Addendum #1

Project Name:	Island Grove Event Center Lighting Upgrade
Bid Number:	RFP #FD20-06-107
Date:	July 10, 2020
Manager:	Dale Blehm / Jimmy Trujillo

Item 3	Drawing Clarifications - see attached drawings. - drawings E100 and E700 updated with job walk notes - replace existing E100 an E700 - notes on E100 and E700 supercede notes on entire drawing set - added detailed coordination drawing for owner supplied fixture type SB - drawing SB 01 with clarifications based on walk thru discussions.

E100

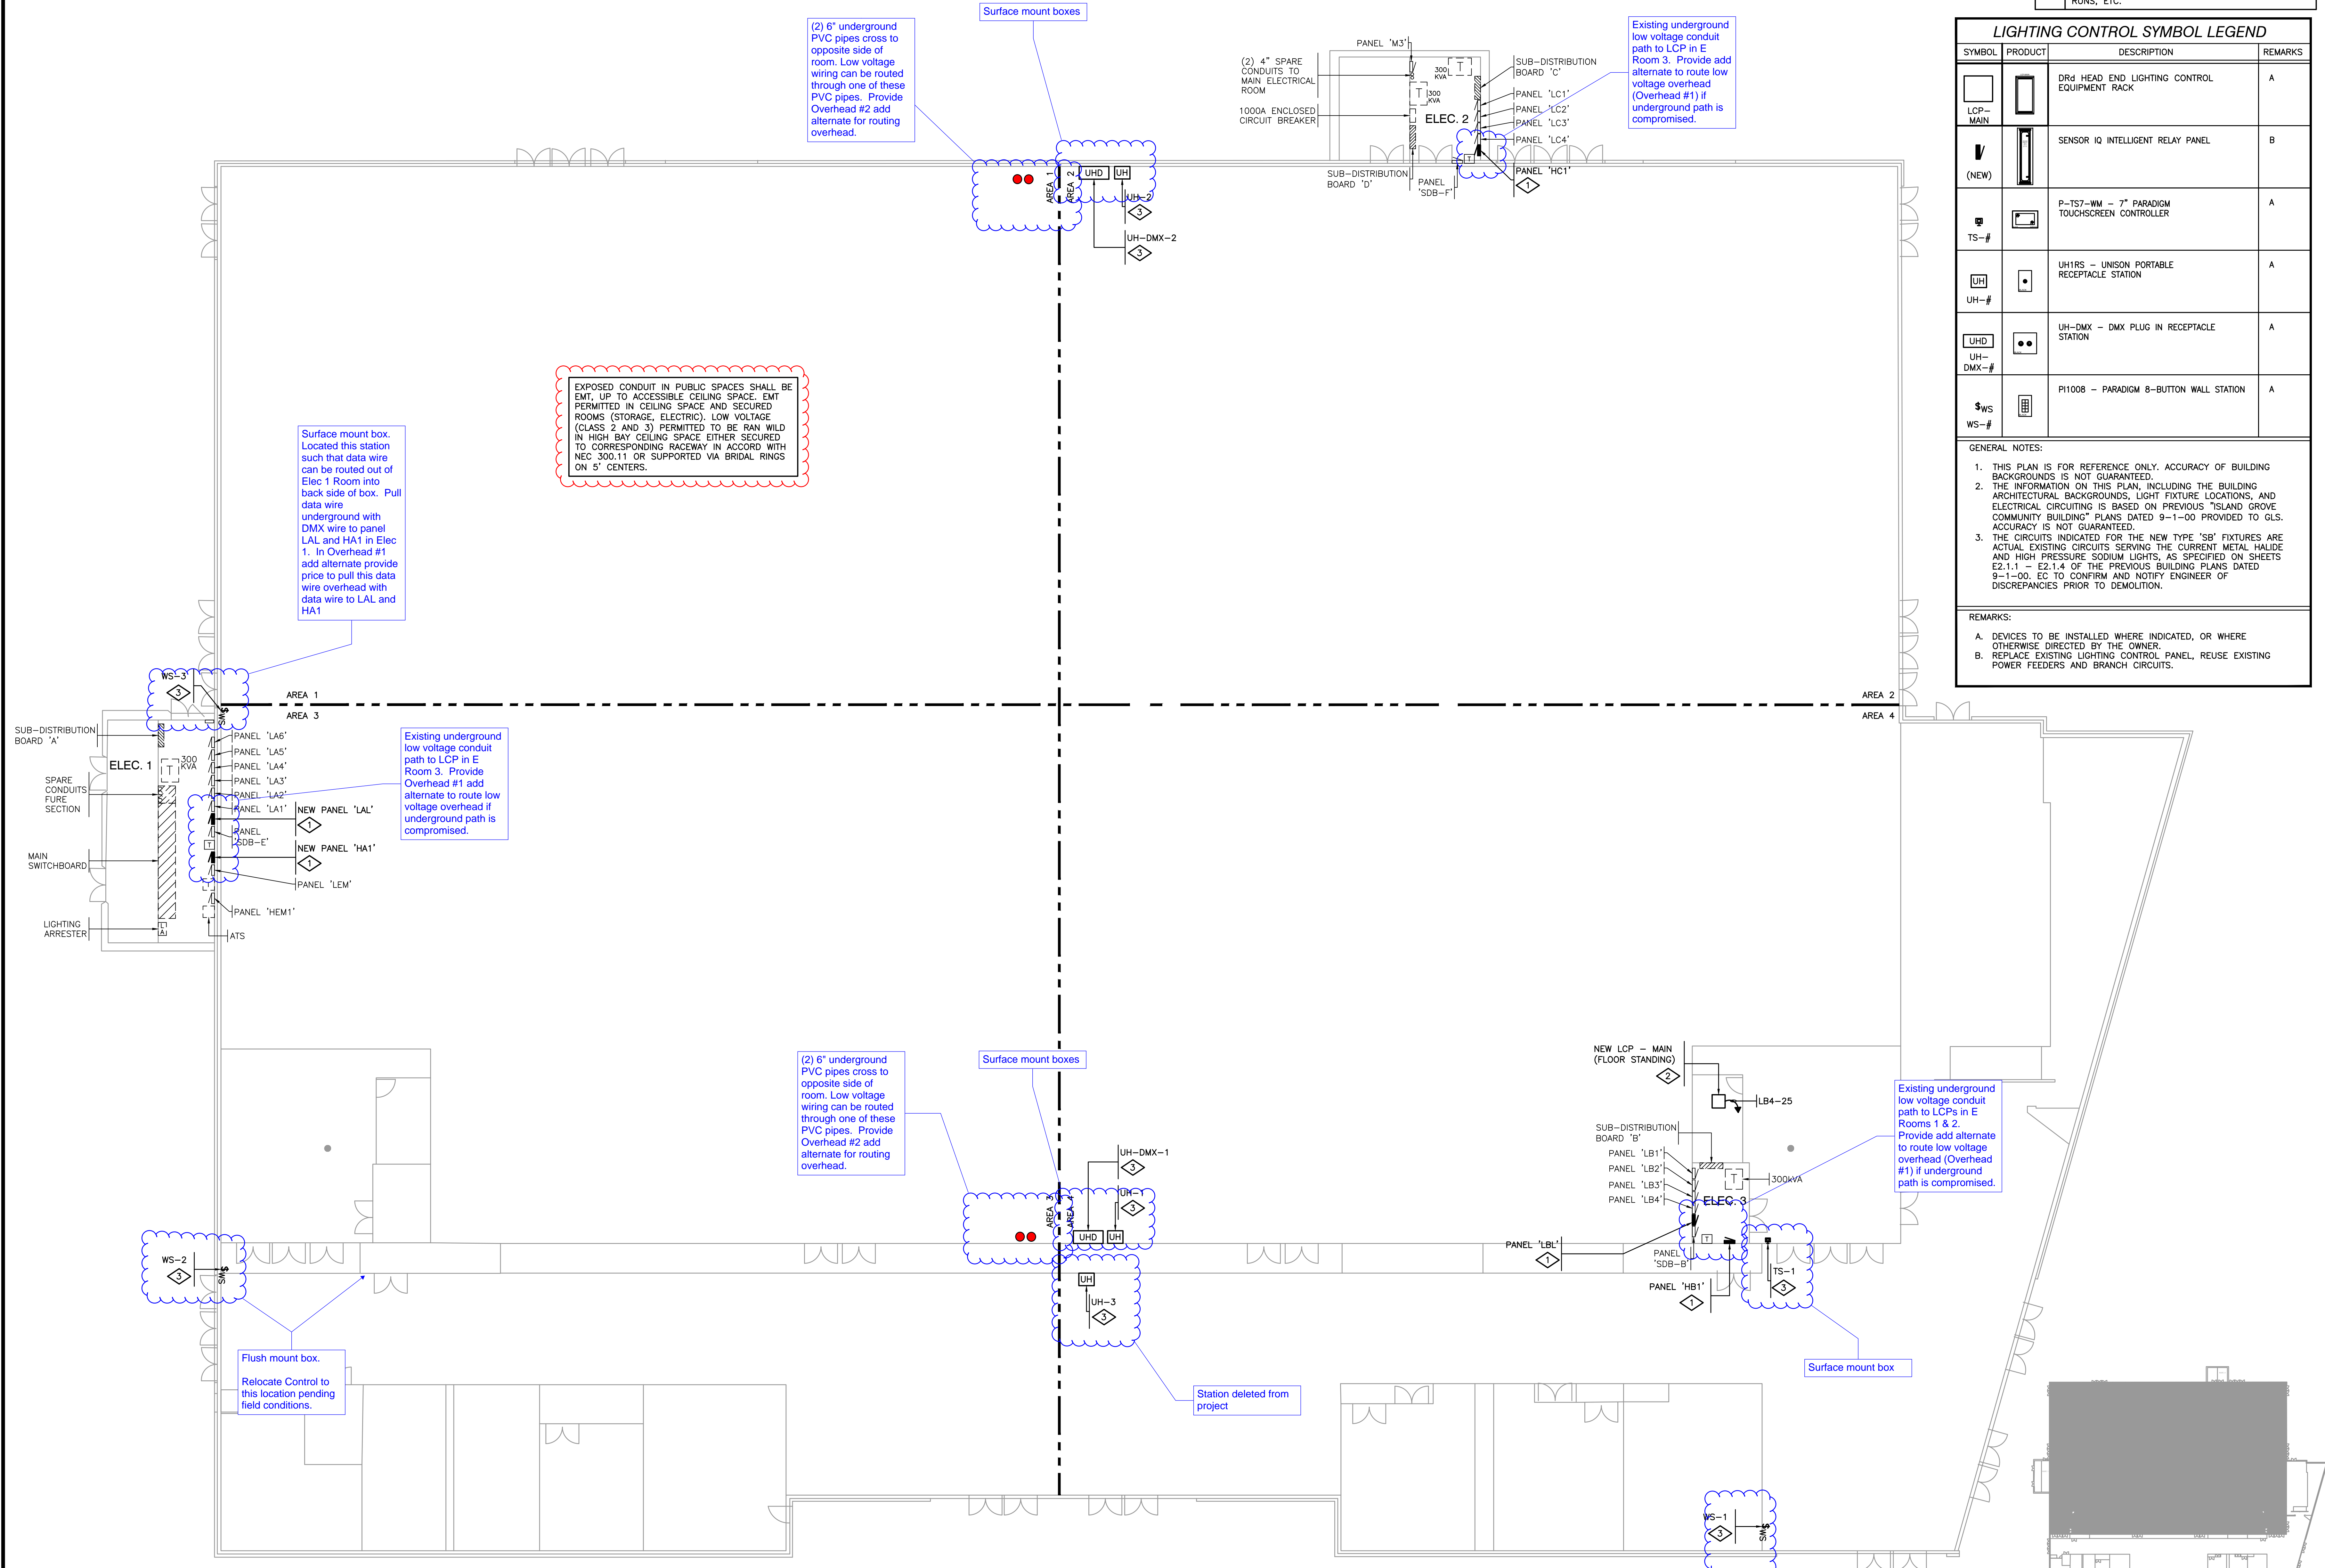
Item 5	There is an empty 6inch conduit in building not shown on the drawings. Can this be used for the control cabling and is the cabling rated to be in this conduit? Attached is an up-dated drawing from the Per-Bid meeting on the existing 6" conduit to be used for the control wiring. Electrical Contractor must provide the correct cabling rating for use in conduit.

Surface mount box. Located this station such that data wire can be routed out of Elec 1 Room into back side of box. Pull data wire underground with DMX wire to panel LAL and HA1 in Elec 1. In Overhead #1 add alternate provide price to pull this data wire overhead with data wire to LAL and HA1

Existing underground low voltage conduit path to LCP in E Room 3. Provide Overhead #1 add alternate to route low voltage overhead if underground path is compromised.

(2) 6" underground PVC pipes cross to opposite side of room. Low voltage wiring can be routed through one of these PVC pipes. Provide Overhead #2 add alternate for routing overhead.

Existing underground low voltage conduit path to LCPs in E Rooms 1 & 2. Provide add alternate to route low voltage overhead (Overhead #1) if underground path is compromised.

Flush mount box. Relocate Control to this location pending field conditions.

1 LOW VOLTAGE LIGHTING CONTROL SYSTEM RISER

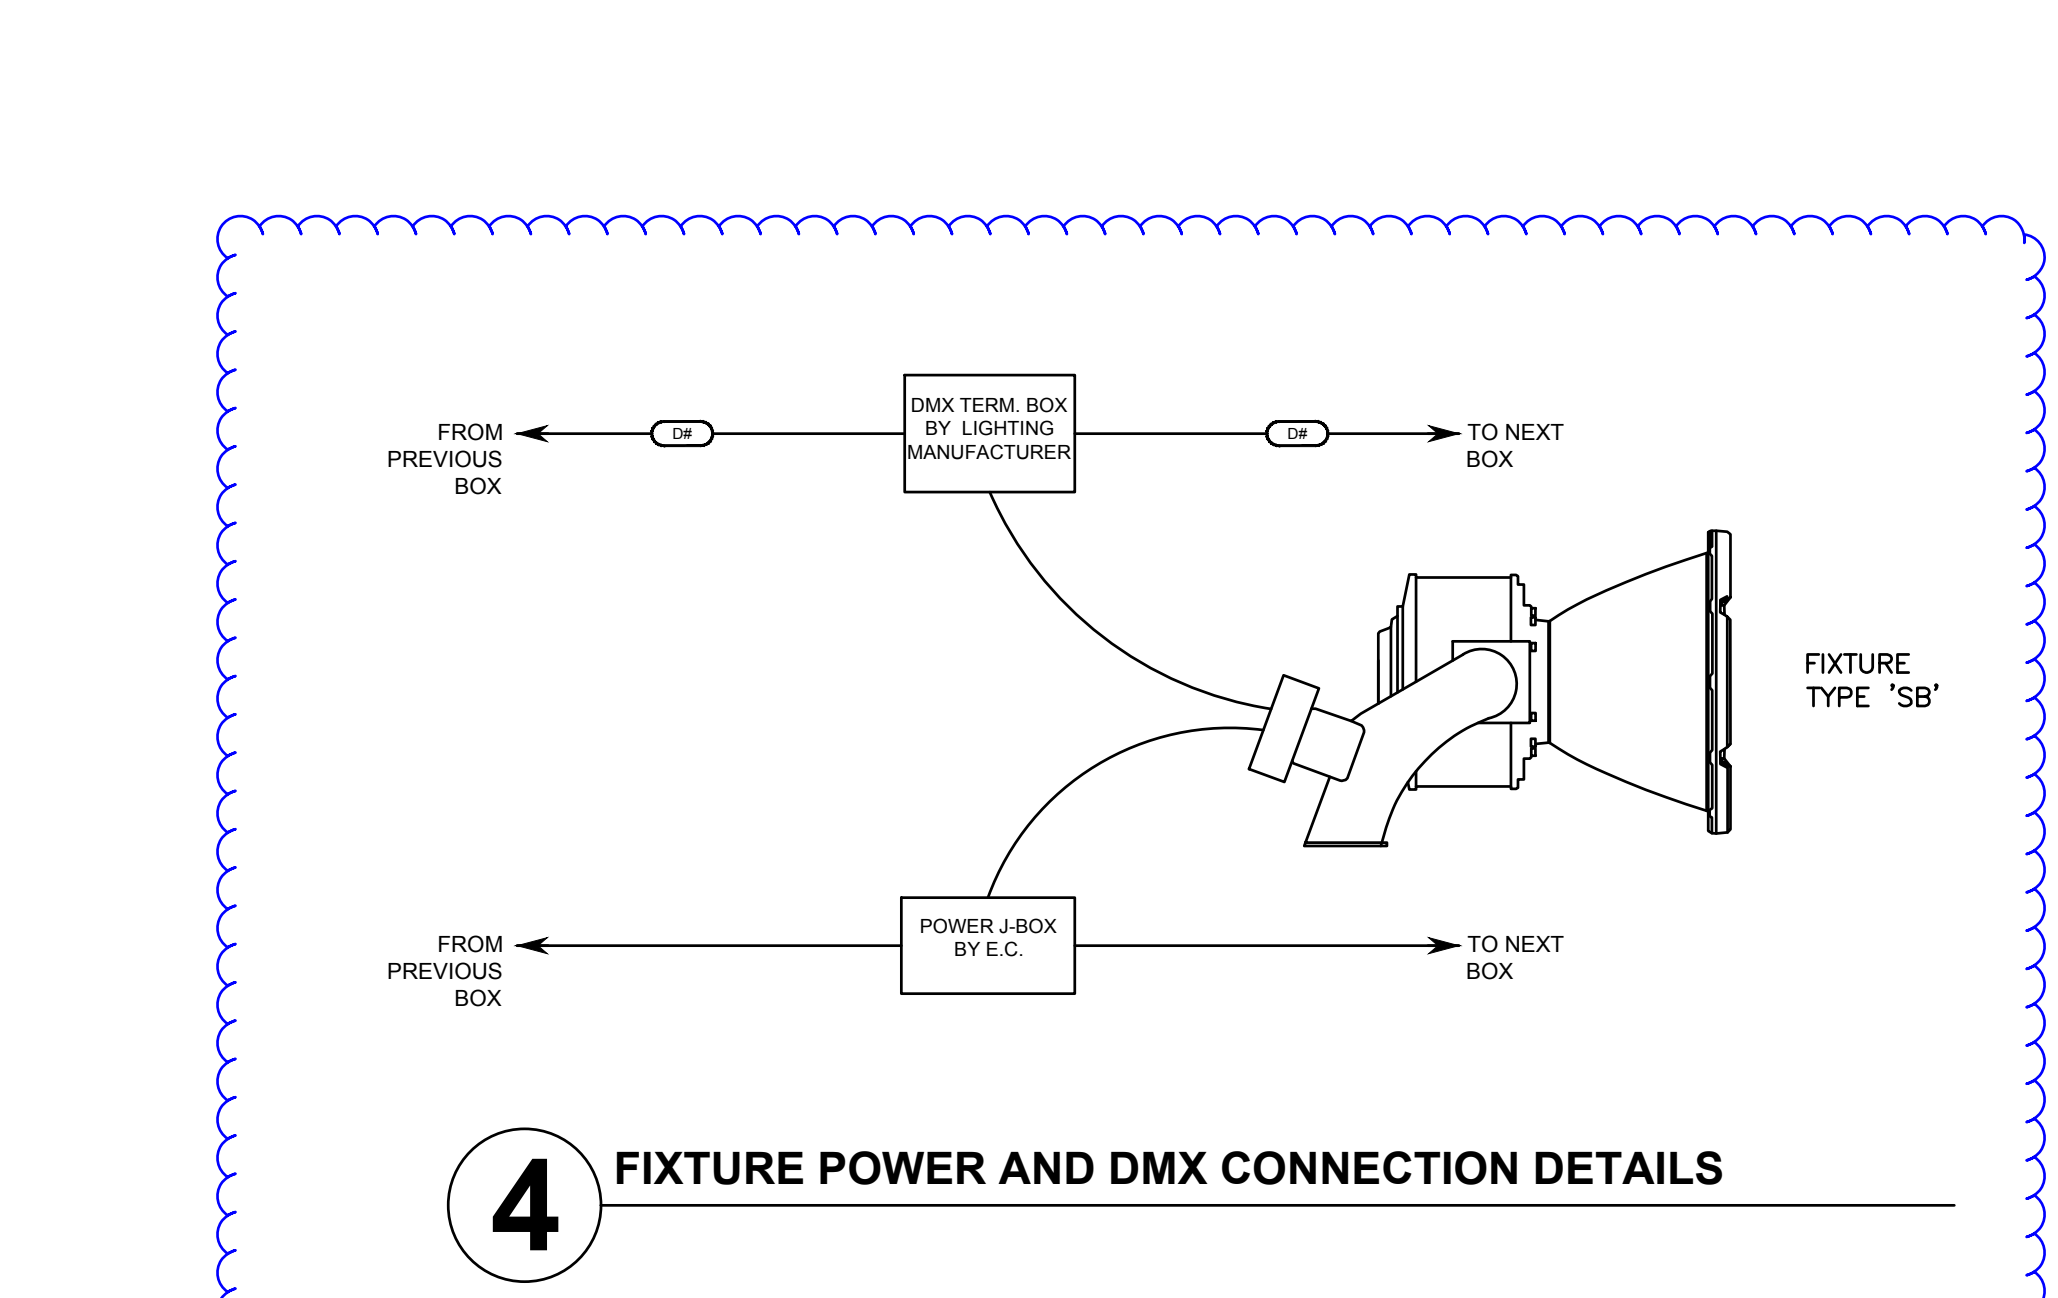
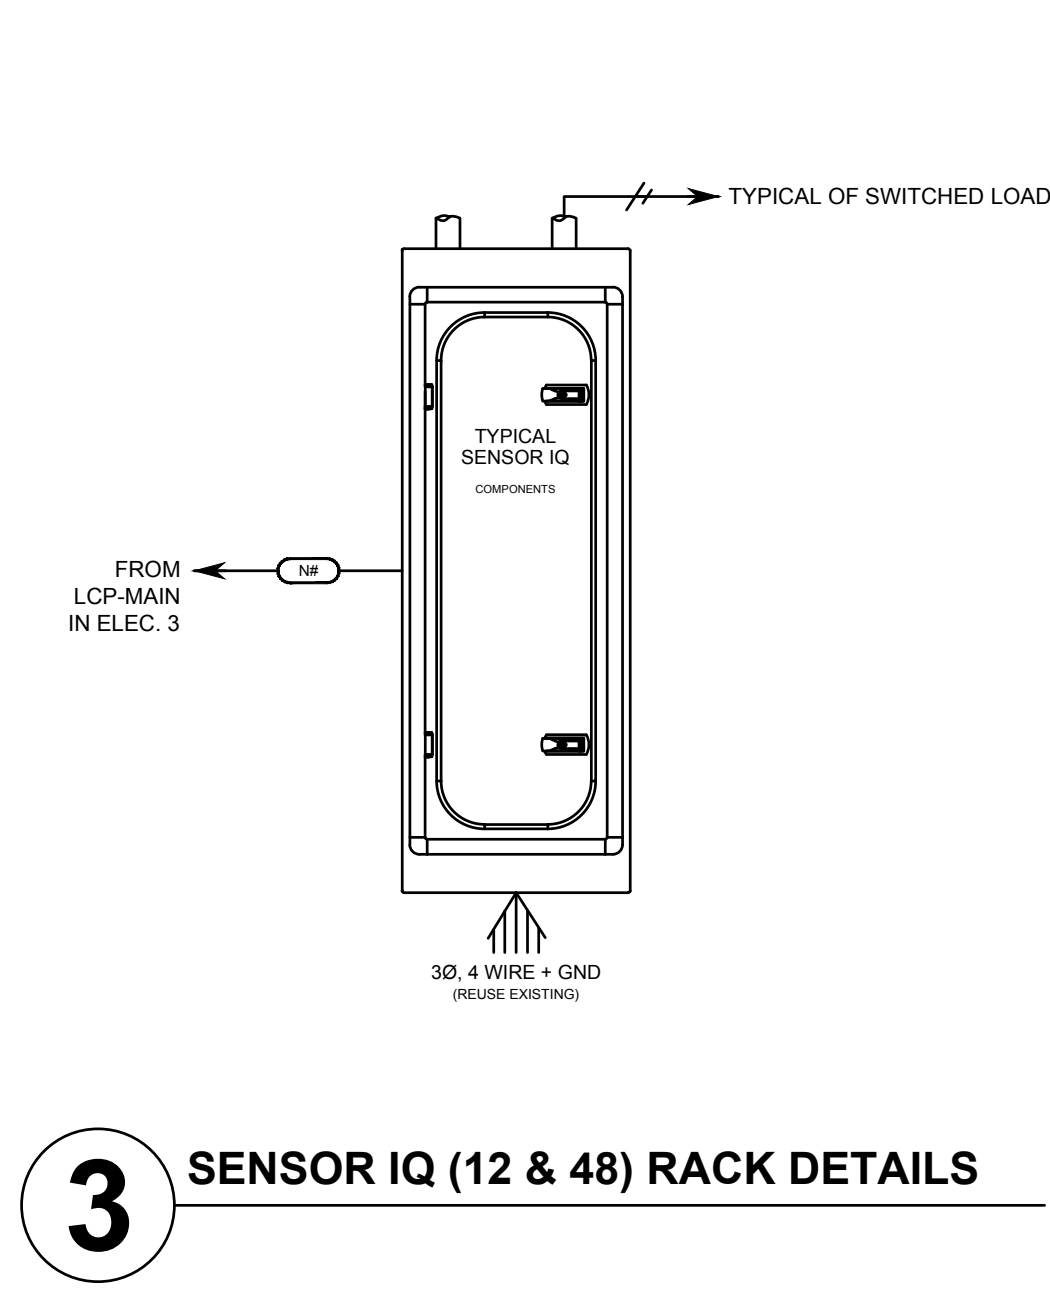
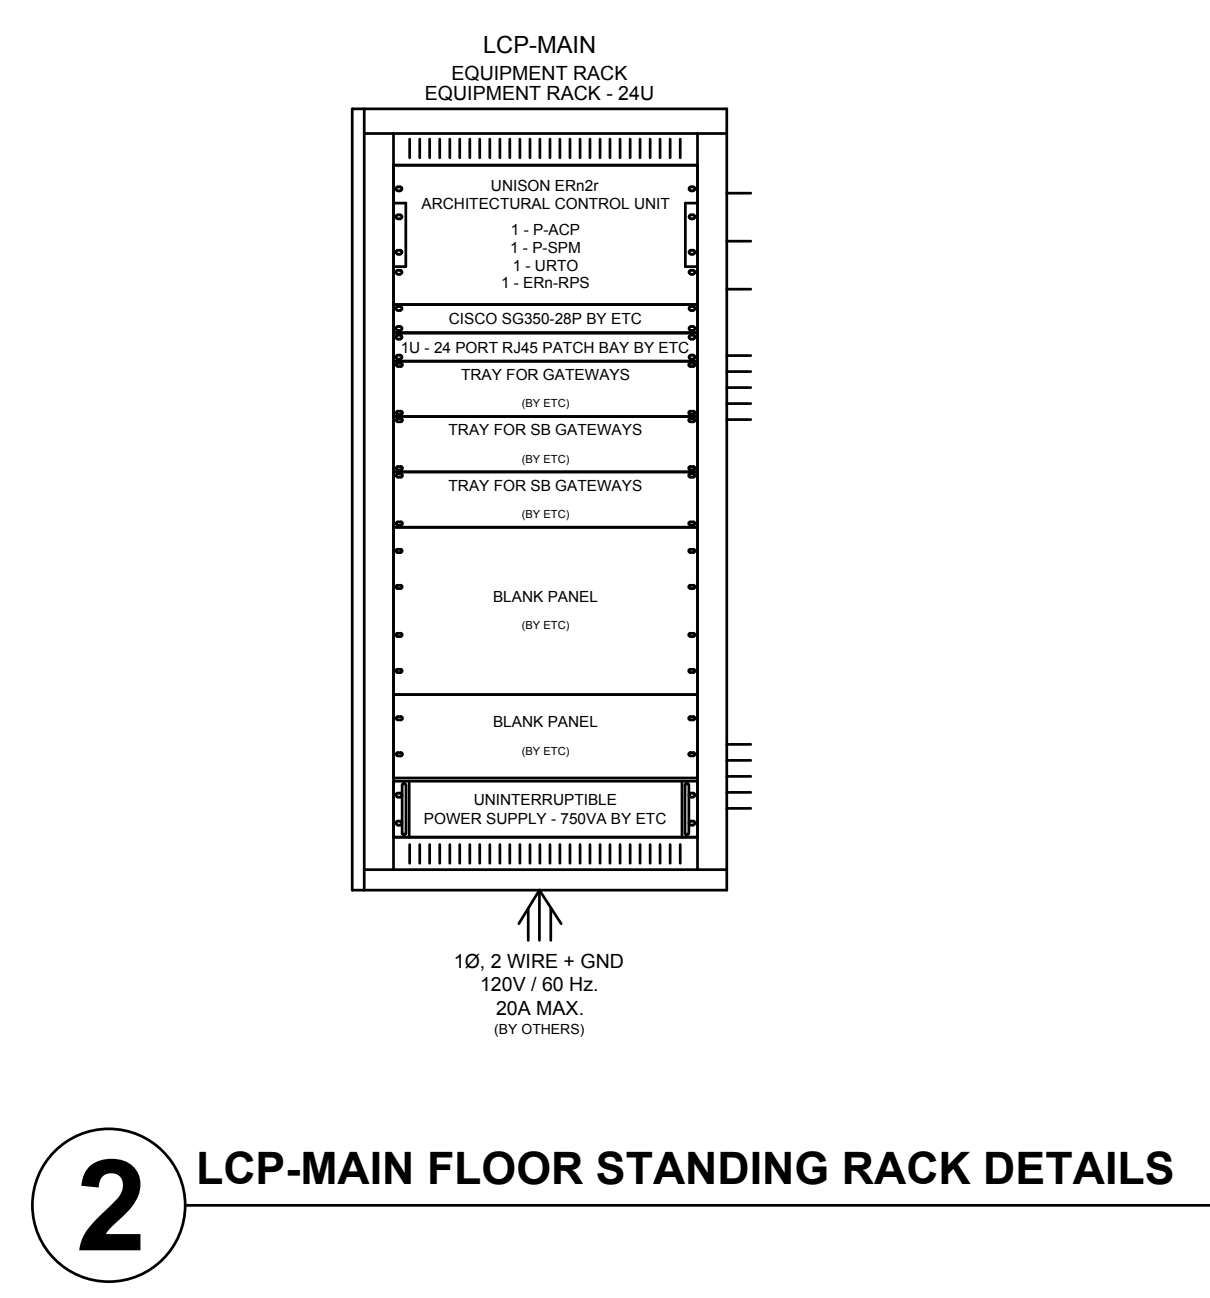
City supplied SB fixtures - fixture will be supplied with 3/4" EMT KO for mounting to existing 3/4" NPT pendants. EC to re-use pendant and existing safety chain for fixture.
